Subject: Foynes to Limerick Road - Adare by-pass
Mainline plan & profile – Rathkeale to Attyflin - section D sheet 7

**MAINLINE PLAN & PROFILE
RATHKEALE TO ATTYFLIN - SECTION D
SHEET 7 OF 12**

Foynes to Limerick Road (including Adare Bypass)
Environmental Impact Assessment Report

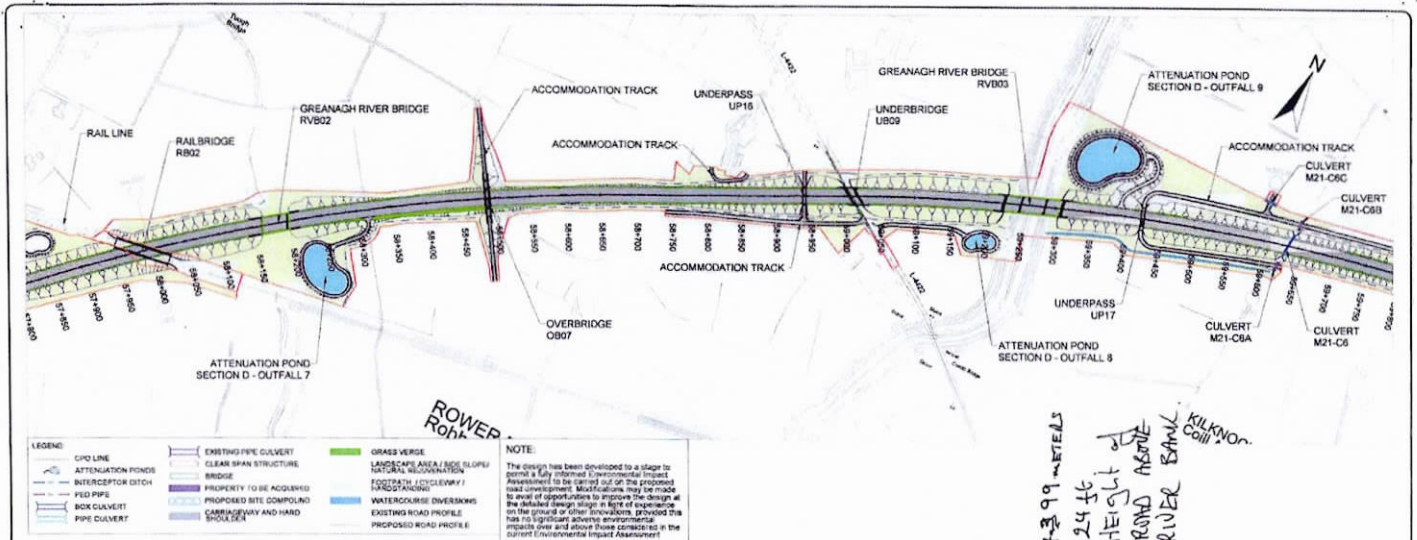
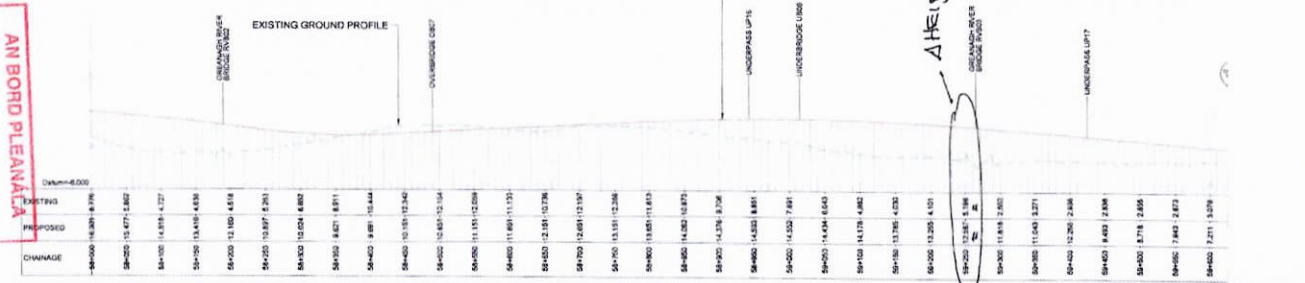
In the proposed outline and finished elevation above existing ground level as set out in the above drawing please note the following real concerns.

Drawing not to scale, does not give full consideration of what the proposed finished build will look like.

At the Greanagh river the proposed finished elevation of the road is 9.2 meters above existing ground level, 30.2 feet.

This will have a very negative imposing impact and disturbance to nearby properties.

This finished elevation is too high and will remain a major **eye sore and ugly** development of a permanent structure.

In addition, **no** photomontage is made available to show the finished proposed development view and a post mitigation view from the L-1422 road.

Handwritten notes:
HEIGHT = 7.399 METERS
= 24 ft
HEIGHT of ROAD ABOVE RIVER BANK
KILKNON CO. IRE.

A satisfactory landscape mitigation, which would be in line with best practice guideline, as set out by the NRA is required.

The proposed design must be in line with best practice, this is not being complied with, height and visual impact are very excessive.

PICTURE #1 - HEIGHT OUTLINE OF ROAD

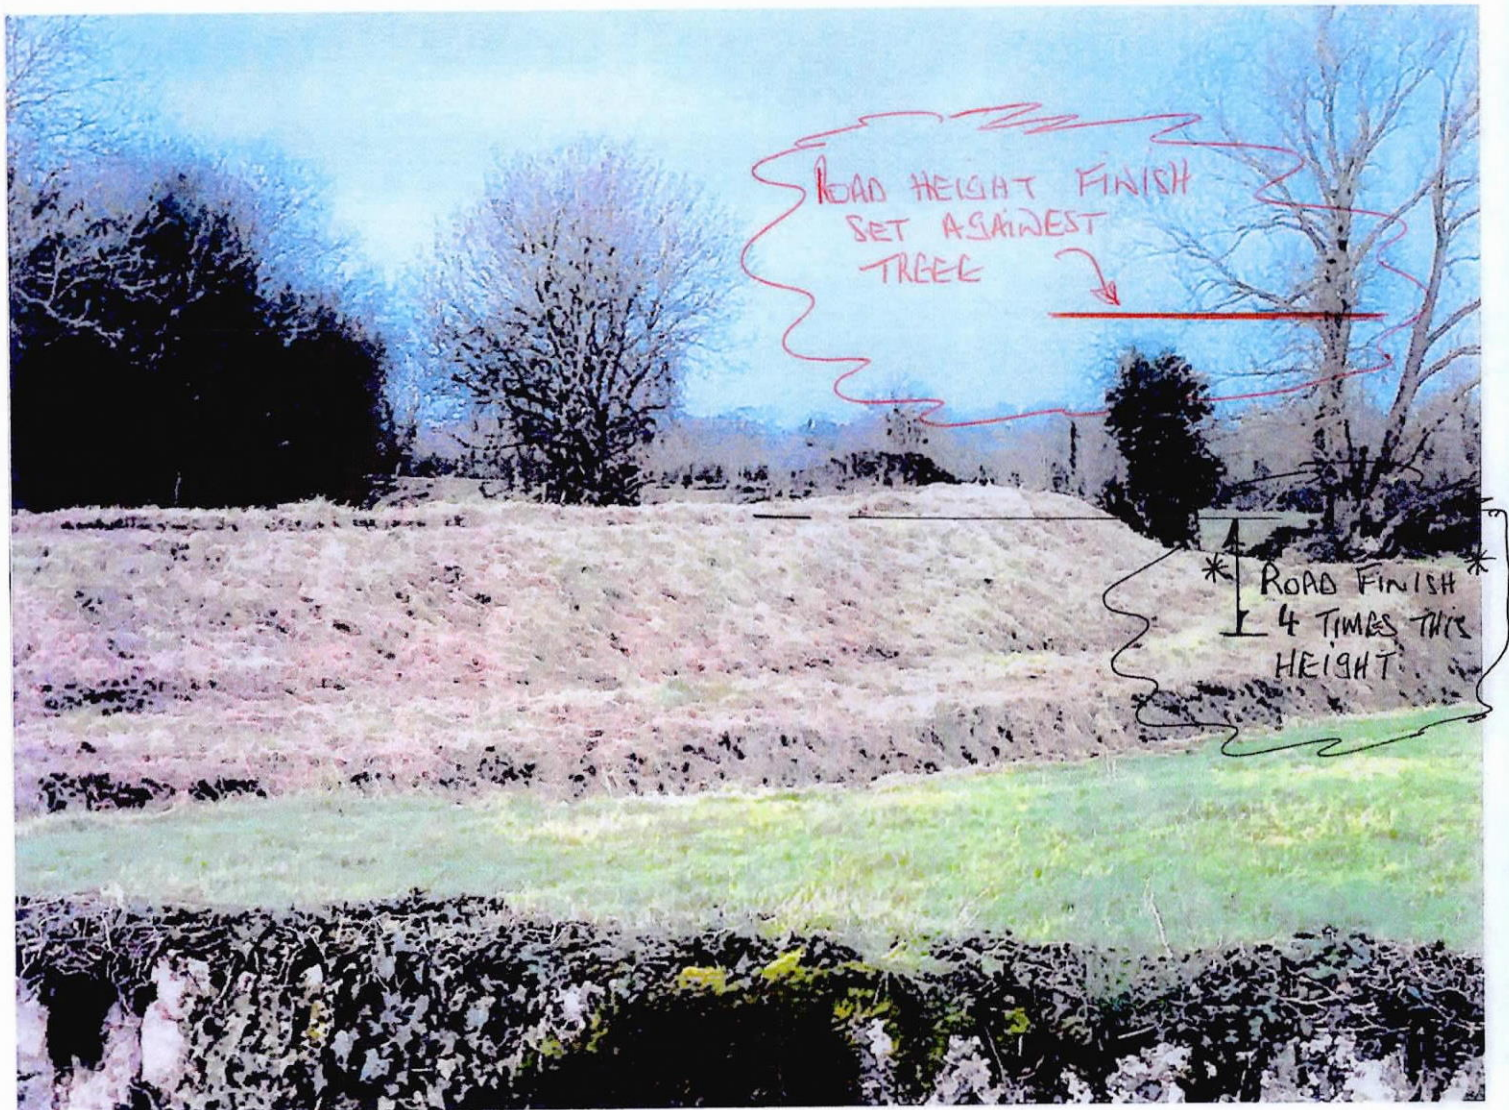
From IDLO REF: FIG 4.44.

AT GRID 59+250 - HEIGHT MEASUREMENTS.

- ROAD FINISHED SURFACE WILL BE '4' TIMES HEIGHT OF BANK.
- ALLOW FOR +4 METERS OF NOISE ABATEMENT BARRIERS HEIGHT.
- EXTENSIVE POST-MITIGATION WORKS REQUIRED TO COMPLY WITH BEST PRACTICE MOTORWAY ROAD BUILD IMPACT.
